**PREFILED STAFF TESTIMONY OF
DAVID ESSAH
ON THE
APPLICATION OF
VIRGINIA ELECTRIC AND POWER COMPANY
FOR APPROVAL AND CERTIFICATION OF
ELECTRIC TRANSMISSION FACILITIES:
REMINGTON-GORDONSVILLE
230 KV DOUBLE CIRCUIT TRANSMISSION LINE**

CASE NO. PUE-2015-00117

**STAFF REPORT
ON THE
APPLICATION OF
VIRGINIA ELECTRIC AND POWER COMPANY
FOR APPROVAL AND CERTIFICATION OF
ELECTRIC TRANSMISSION FACILITIES:
REMINGTON-GORDONSVILLE
230 KV DOUBLE CIRCUIT TRANSMISSION LINE**

CASE NO. PUE-2015-00117

Oak Green Junction – Mountain Run Junction

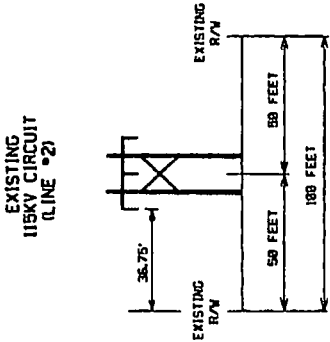
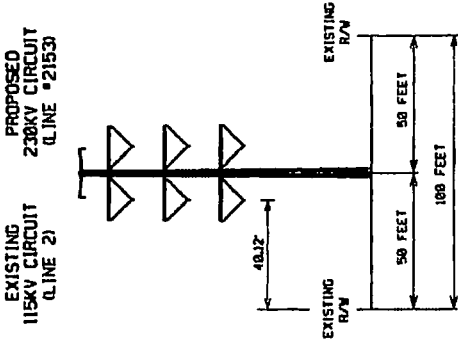
7
8 Within the corridor from Remington Junction to Gordonsville, the
9 approximate average height of the new transmission structures would range from
10 103 to 107 feet. In response to a Staff interrogatory, the Company explains that
11 the basis for the proposed structure heights is to provide the Company-required
12 230 kV ground clearance needed for a structure-for-structure replacement within a
13 100-foot wide ROW.³¹ In comparison, the average height of the existing H-Frame

structures ranges from 50 to 69 feet.³² Cross-arm widths would also change from 27-42 feet for the existing H-Frame structures, to a proposed width of 34 feet for the new monopoles. The tallest structures along the entire Proposed Route would be existing structures found along the 0.62 mile long Remington Junction – Remington Substation corridor where the new Line #2153 would share the same double circuit structures as 500 kV Line #535.

The proposed approximate average pole heights will provide the Company-required 230 kV ground clearance in a structure-for-structure replacement in a 100' right-of-way. See the Company's response to Question No. 47 of the Staff's Fourth Set.

Pictures of Projected Surface Finish for Proposed Structures

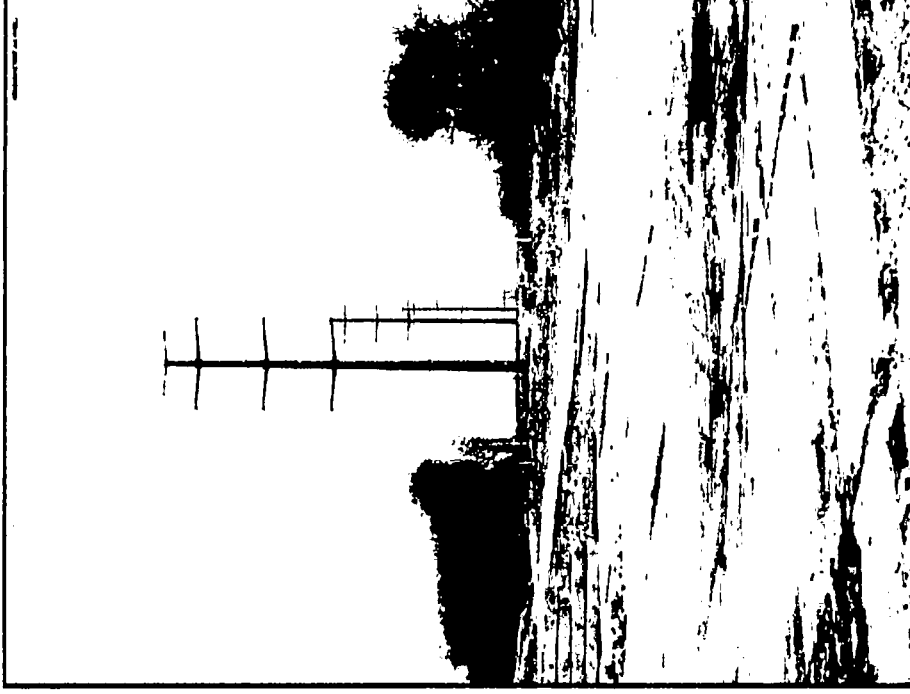
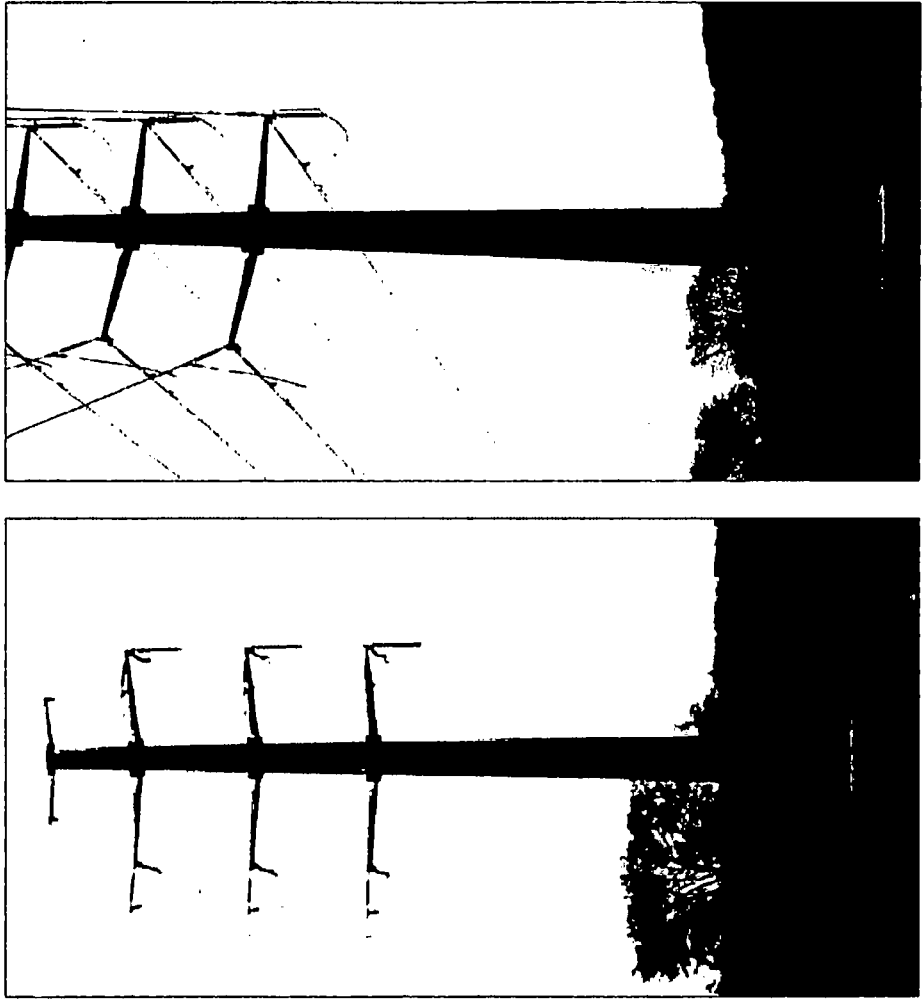
- a. Please state whether the weathering steel structures proposed for the Project comply with the Virginia Outdoors Foundation's ("VOF") recommendation to use dulled steel structures for the Project (See Department of Environmental Quality ("DEQ") Report).
- b. Please provide color pictures showing the expected initial surface finish of a typical weathering steel structure to be used for the Project, and the projected surface finish of a "weather-dulled" structure after 5 to 10 years of weather exposure.
- c. Please provide similar pictures for a galvanized structure.

12 In response to a Staff interrogatory, the Company stated that the structures
13 proposed for the Project are non-reflective, rust-colored or brown structures that
14 are consistent with the dulled-steel structures proposed by the Virginia Outdoors
15 Foundation ("VOF") in the DEQ Report.⁵⁹ The Company provided Staff with
16 pictures showing the expected initial surface finish of a typical structure, and the
17 projected surface finish after approximately eight years of weather exposure
18 (Attachment 5). Based on its investigation, the Staff concurs that this proposed
19 choice of surface finish is a prudent choice that reduces visual impacts of the
20 Project.
